TENTATIVE ORDER OF DISCUSSION 2013 PROPOSED CHANGES TO THE INTERNATIONAL RESIDENTIAL CODE – PLUMBING

RP1 – 13

P2502.1

**Fig. 1 Typical Cross-Section
(For Illustrative Purposes Only)**

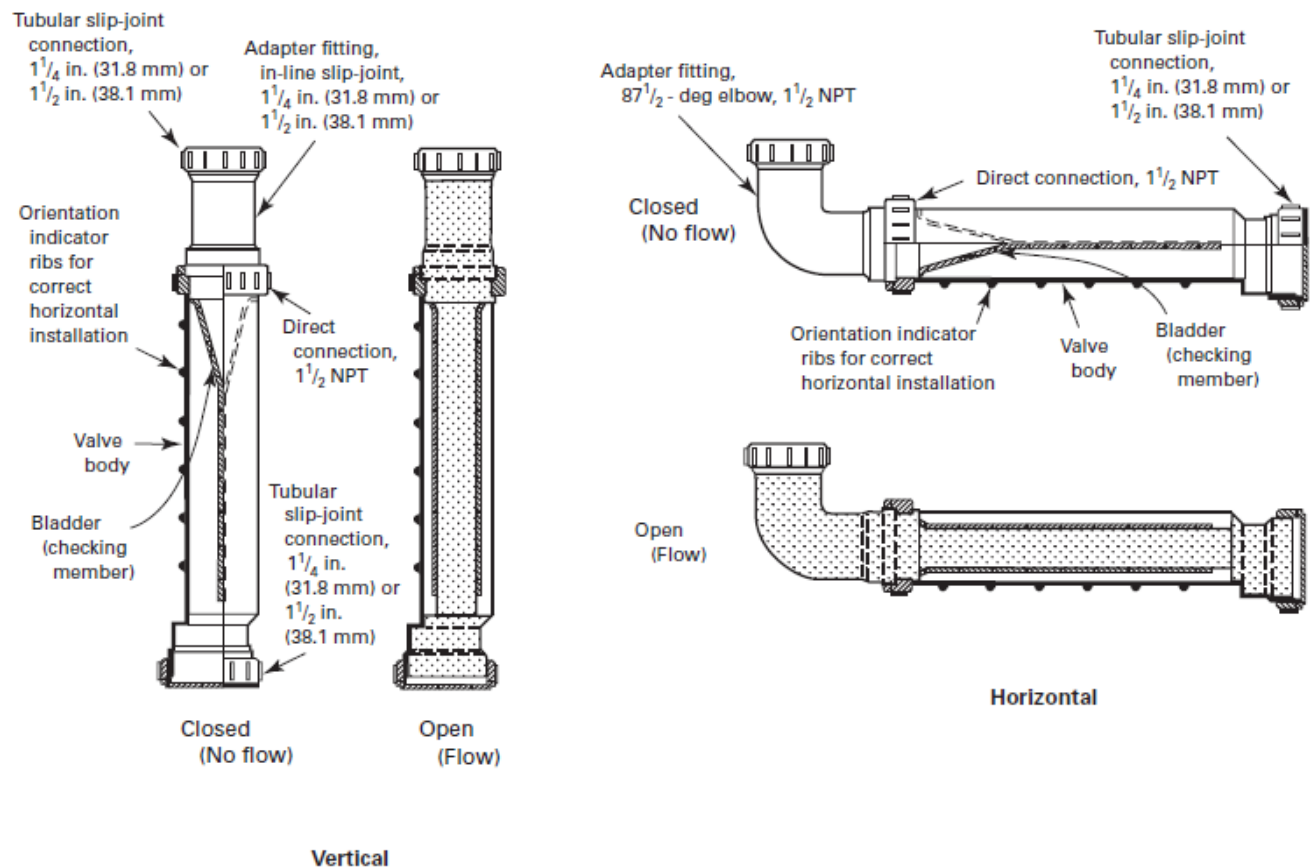
Reason: There is a new ASME standard ASME A112.18.8 that has been developed for sanitary waste valves and there are products that have been tested to meet or exceed the standard's requirements. Last year elastomeric trap seal protection devices were added to the IPC. This device is similar, but limited to tubular drains in lieu of a p-trap. It is not subject to floor wax and debris that a floor drain will receive. The key sections of this proposal are Section P3201.6 and new Section P3201.6.1 that add an alternative to liquid seal traps. All other sections being modified are in support of adding this alternative to the code. Inline sanitary waste valves can only be used on fixtures that have 1-1/4 inch or 1-1/2 inch OD tubular waste outlets from fixtures, so their application is generally limited to sinks, lavatories and bathtubs. The testing requirements of the standard for inline sanitary waste valves are stringent. In many applications, inline sanitary waste valves offer better, more reliable protection (against sewer gas coming out of a fixture) than a liquid seal trap.

In-Line sanitary waste valves now have an Industry standard ASME A112.18.8–2009 titled: "In-Line Sanitary Waste Valves for Plumbing Drainage". These devices have been tested and certified by third party testing labs and they have been proven over many years of use to provide a reliable gas-tight seal when used in lieu of a p-trap. They provide a seal which is not dependent on operating conditions and is not affected by evaporation or siphonage. These valves are mainly used in situations where sanitary fixtures see only occasional use, where freezing conditions, low humidity, persistent high temperature conditions, or where there are limited or confined space conditions. Examples include guest bathrooms, seasonal occupancy dwellings, manufactured housing and in remote cabins. Other common uses for this type of device are in Recreational Vehicles and boats for the freeze resistance and splash resistance. The performance requirements for the device are covered within the ASME A112.18.8 ANSI approved Standard, which includes a gas-tight seal test, flow rate test, long term cycling tests, a grease or lard test and many other chemical resistance and solids tests. These valves perform in a similar manner to a trap seal protection valve. Elastomeric type devices in the drainage system are already approved in the International Plumbing Code. In 2012 when the Trap Seal Protection Devices

The scope of the ASME A112.18.8 Standard establishes minimum requirements for materials in the construction of sanitary waste valves for use as an alternate to tubular p-traps, and prescribes minimum test requirements for the performance of the valve, together with methods of marking and identification. The ASME A112.18.8 Standard does not define the requirements for products to be used in urinals or water closets. It is not intended that products meeting this Standard will be used in a urinal or water closet.
